From: Dick Christie [dchristie@InfoAve.Net]
Sent: Wednesday, December 28, 2005 2:18 PM
To: Alison Guth
Subject: FW: American Eel Report

From: Alison Guth [mailto:Alison.Guth@KleinschmidtUSA.com]
Sent: Monday, December 19, 2005 11:34 AM
To: Steve Leach; 'Prescott.Brownell@NOAA.gov'
Subject: FW: American Eel Report

MEMORANDUM

TO: Saluda Hydro Project Relicensing Stakeholders

| **Figure 1. Proposed Macroinvertebrate Sampling Locations in the Lower Saluda River Downstream of the Saluda Hydroelectric Project Dam**

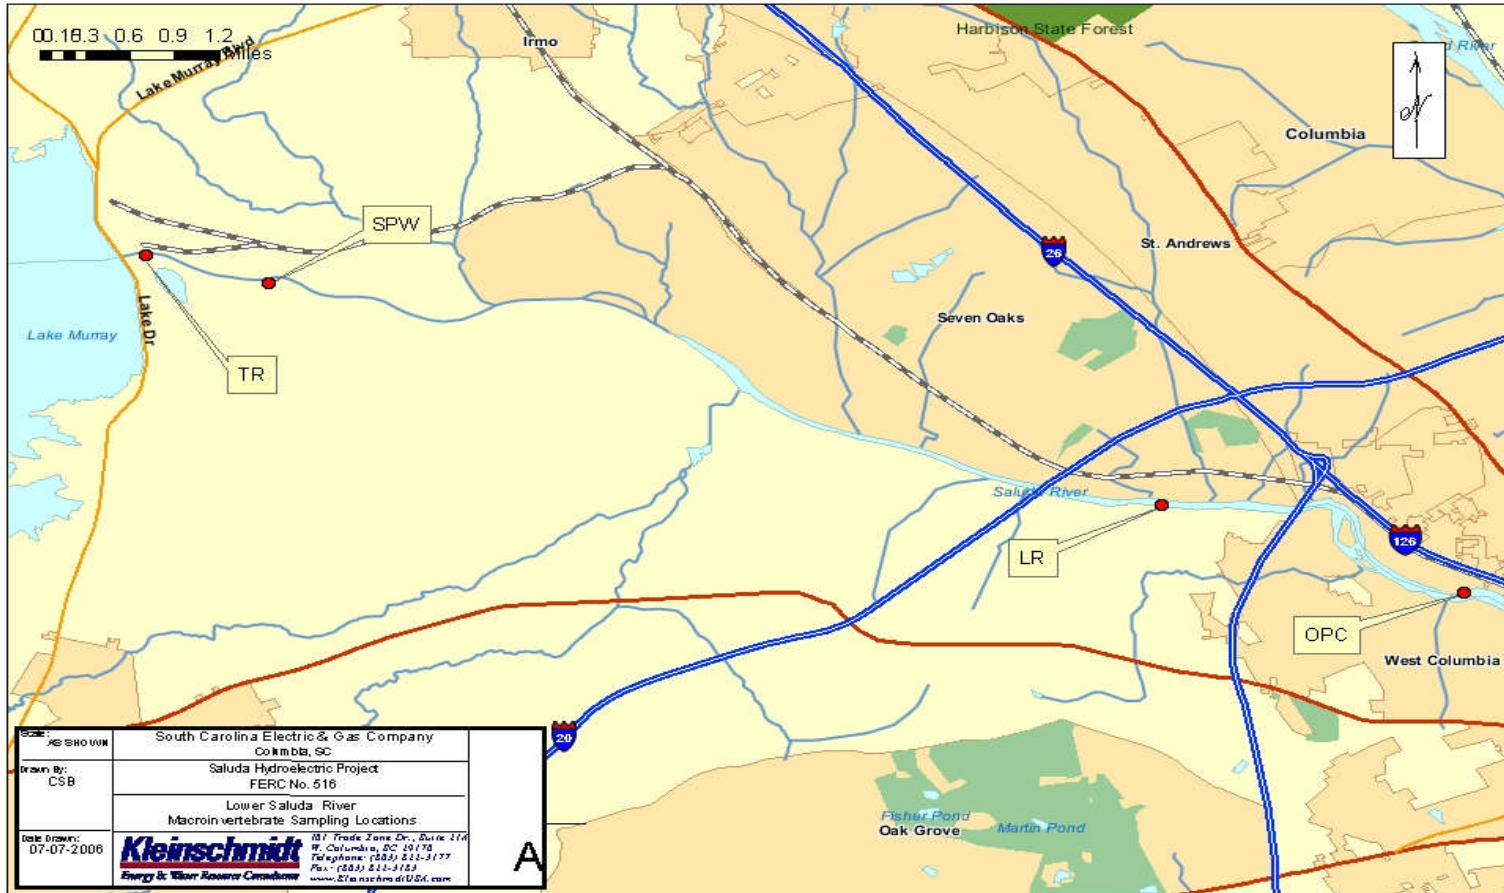
Comment: Per the below this would actually be 3 locations for the main channel of the Saluda since the SPW site is not representative. This leaves a 5 plus mile gap between the TR and LR sites. I recommend adding at least one more main channel site between TR and LR

Comment: I don't understand why this location is to be sampled unless it is to get separate information on the spillway channel. The spillway channel is quite different than the main channel.

Comment: It appears on the map that LR and OPC sites are near tributary streams. I recommend not sampling immediately downstream of any tributary to avoid tributary influence. If a site MUST be near a trib due to access (... [2])

The spillway site was originally added due to the problem of finding relatively low-velocity areas in the lower Saluda River. The TR samplers were fastened to the I-beam (in the channel in the I-beam) which forms the downstream leg of the USGS monitor. The spillway samplers were hung from overhanging vegetation just inside the channel of the spillway where it enters the river (far enough in to keep them out of the current).

The OPC samplers were hung from the USGS sampler (02169000). I didn't consider this an ideal location, but there is no boat access in this area.
